BAR 05-06-05

405 Ridge Street

Demolish and Replace 2nd House; Remove Aluminum Awning and Add New 4-Season Room on Main House; Replace Siding and Tower Roof, Replace Fence, Paint Exterior
Jeff and Susan Lanterman, Applicants

**CITY OF CHARLOTTESVILLE
BOARD OF ARCHITECTURAL REVIEW
STAFF REPORT
June 21, 2005**

CURRENT PHOTO 6/15/05

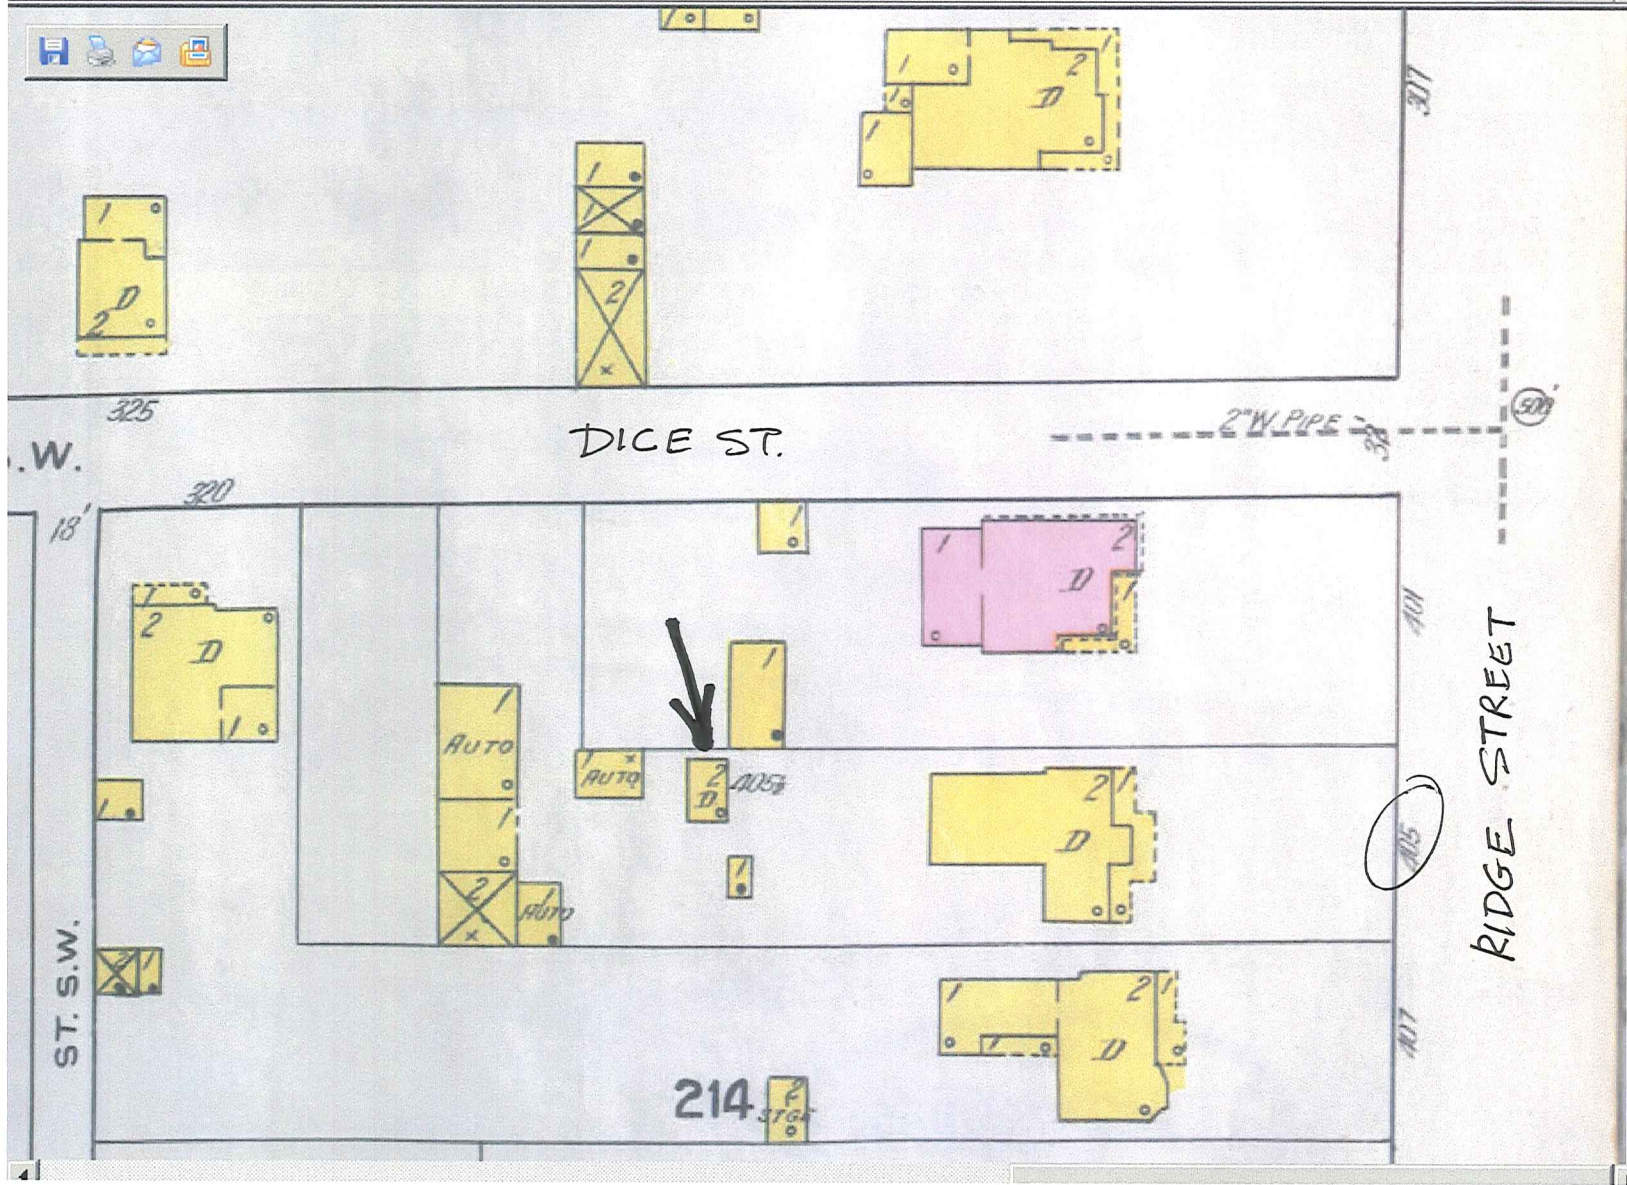
4. Fiber cement siding is acceptable, given it is replacing asbestos shingle. Staff recommends limiting the scalloped siding shingles to the gable areas, and to the top of the tower down to the definite line that was formed by horizontal trim (which has been temporarily removed). Taking it o the middle of the windows would look arbitrary. More information is needed on what is proposed regarding the fascia, frieze, and other trim.

The BAR approved (7-2) the fiber cement shingle sample as presented, with the shingles to come to the break line on the tower as noted by staff [and to cover the gable areas]. Trim details were also approved, that is, to remove the metal coverings and restore the wood, or to replace the trim with wood.

Sample
fence

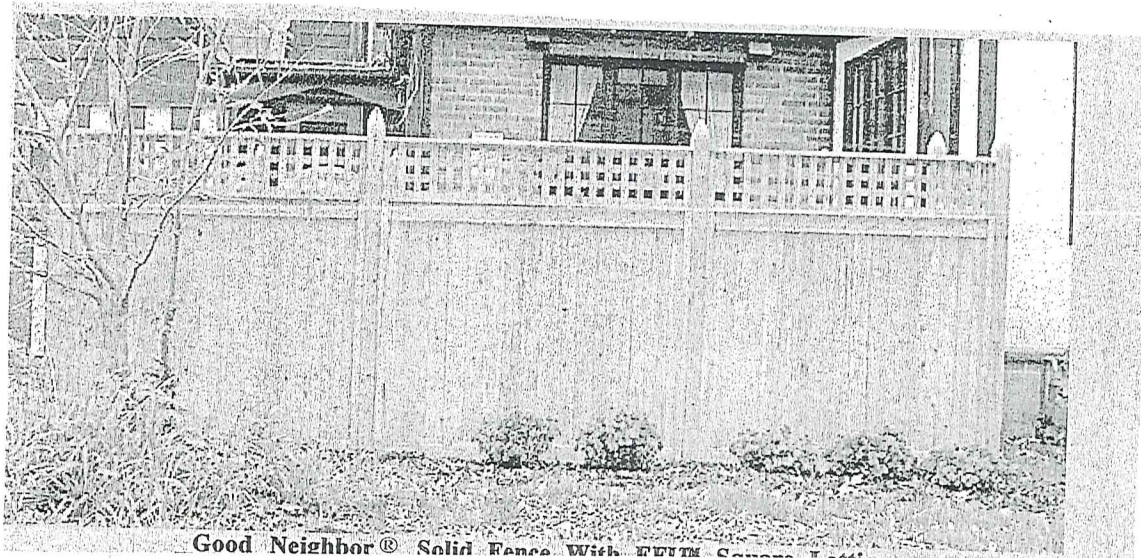
How tall will the privacy fence be? Will it have gates? It is described as "slats allow light and airflow" but the picture looks like the slats are solid. Which is correct?

The BAR approved (9-0) a privacy fence in the rear yard of 4-6 feet in height, with gates to be approved administratively; the paint scheme for the main house; and wood shutters as described per the guidelines.

~~SOUTHERN~~
~~NORTHERN~~ ELEVATION

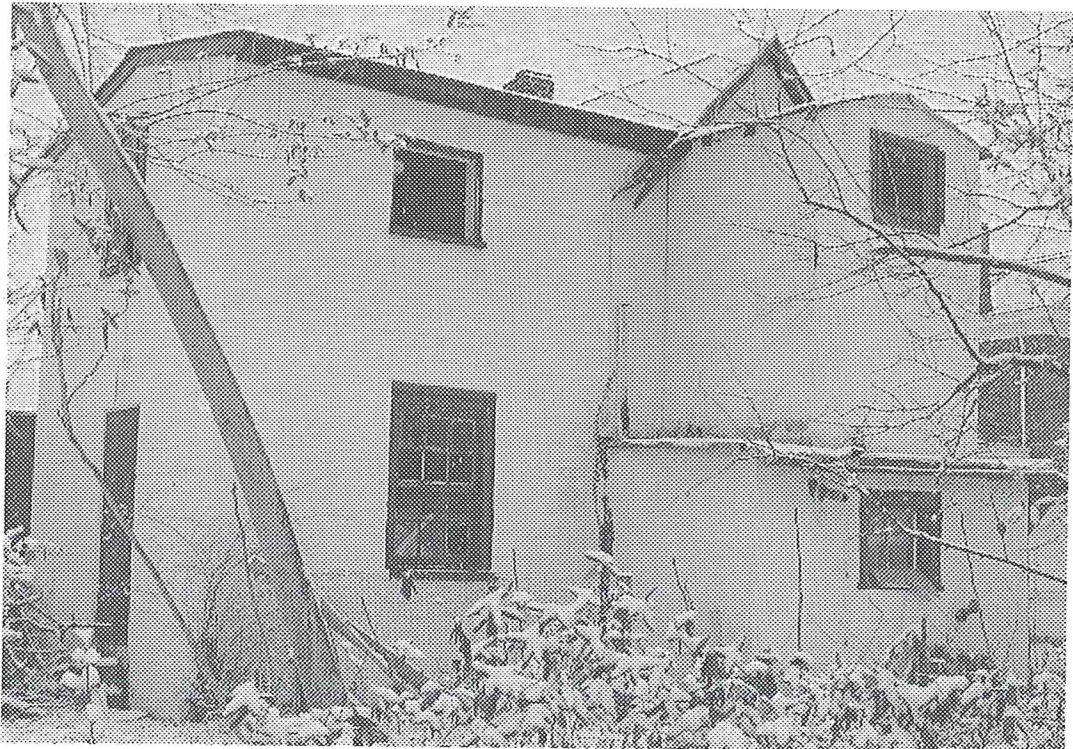
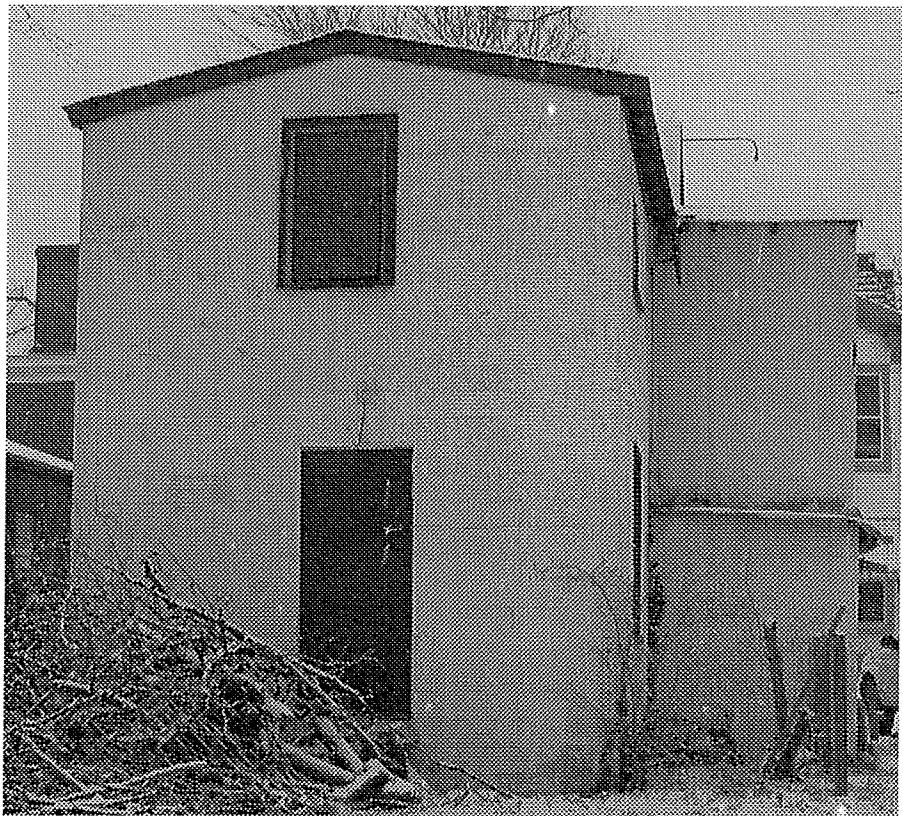
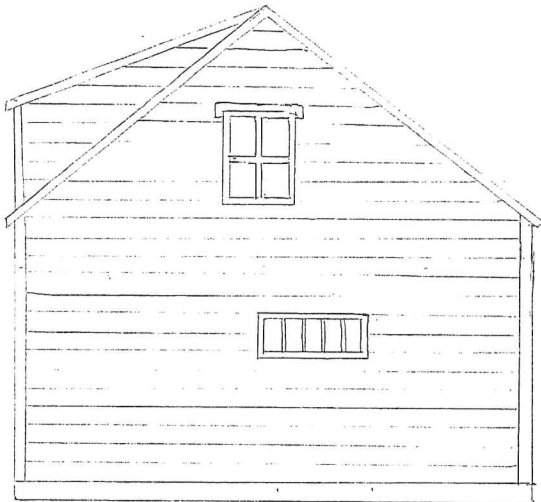
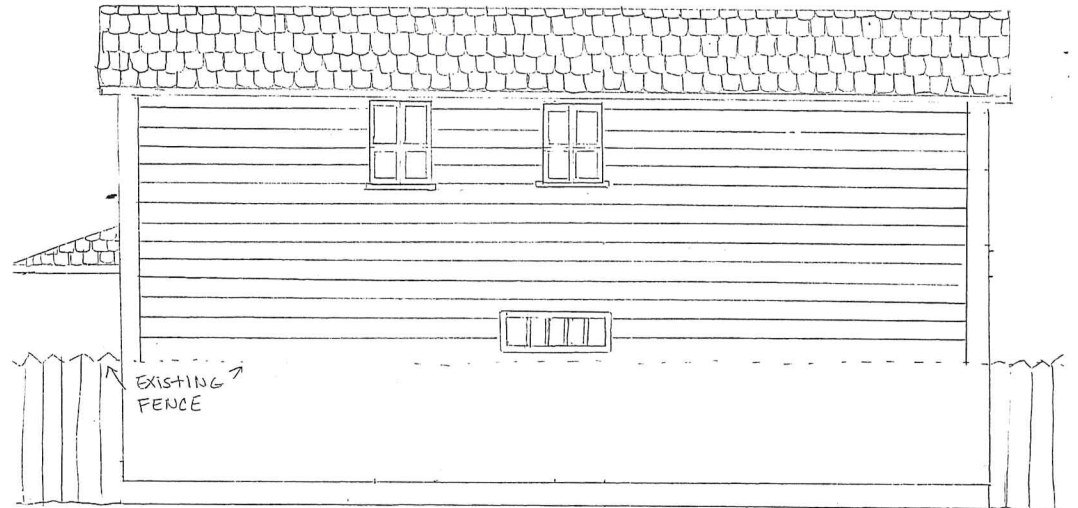
I'd like to have more information on the proposed 2nd house before I can recommend action. What are the dimensions? The new house appears to be facing Dice Street, where your fence is proposed. Are the elevations labeled correctly? Also, the side elevations do not correspond with the other elevations (roof and dormers).

The applicants deferred their request to replace the second house until more detailed plans could be prepared. One member of the BAR noted that he would prefer and encourage the applicant to consider the appearance of the original when designing a replacement structure.

Proposed 4-Season
Room

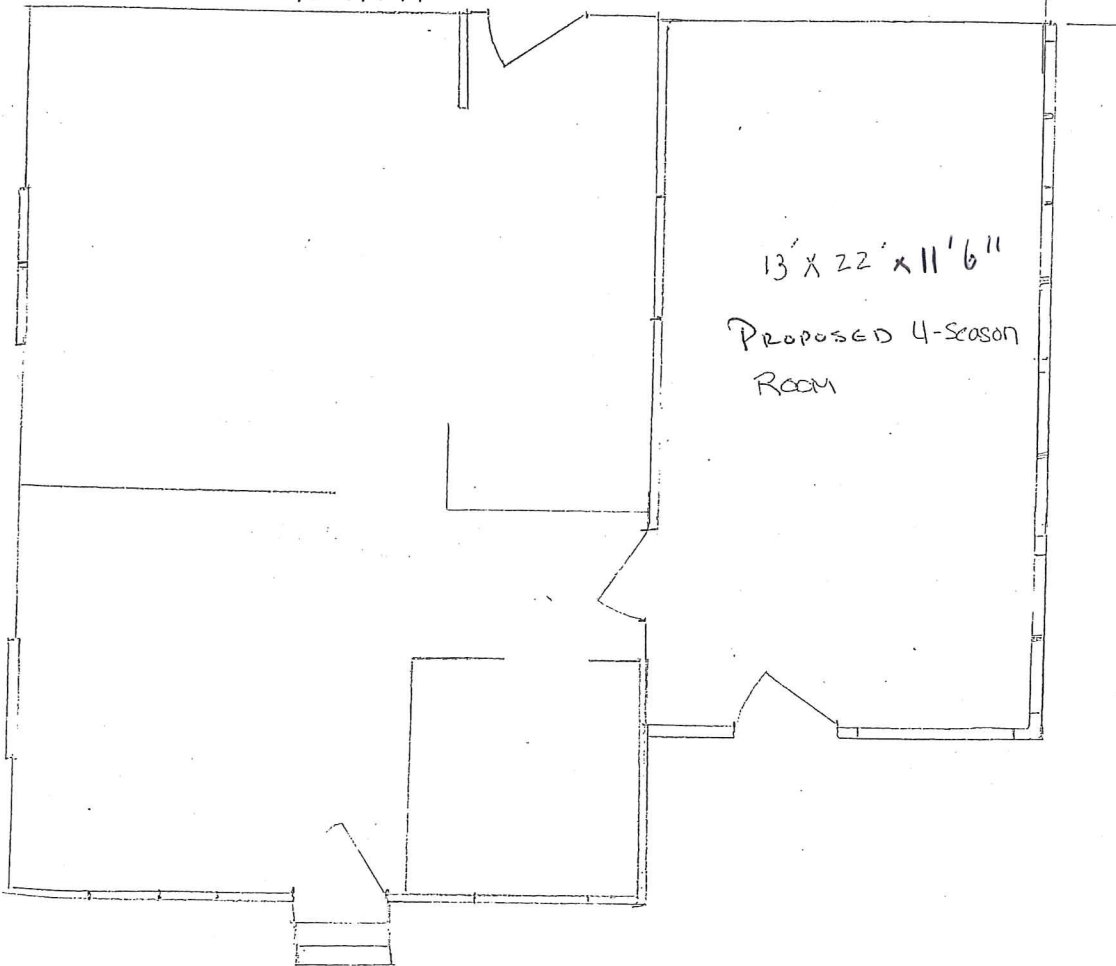
3. Staff recommends demolition of the aluminum awning and construction of the new 4-season room as proposed. A metal hip roof would also be appropriate over the enclosed room..

The BAR approved (9-0) the new four-season room as submitted, including details as described by the applicant: wood windows; transoms to align with the windows below; hardi-plank corner boards and smooth siding; wood eaves; wood pickets; and rubber membrane roof with metal flashing. When the drip edge detail is worked out, please submit it for approval to either Mary Joy Scala or Joseph Atkins.
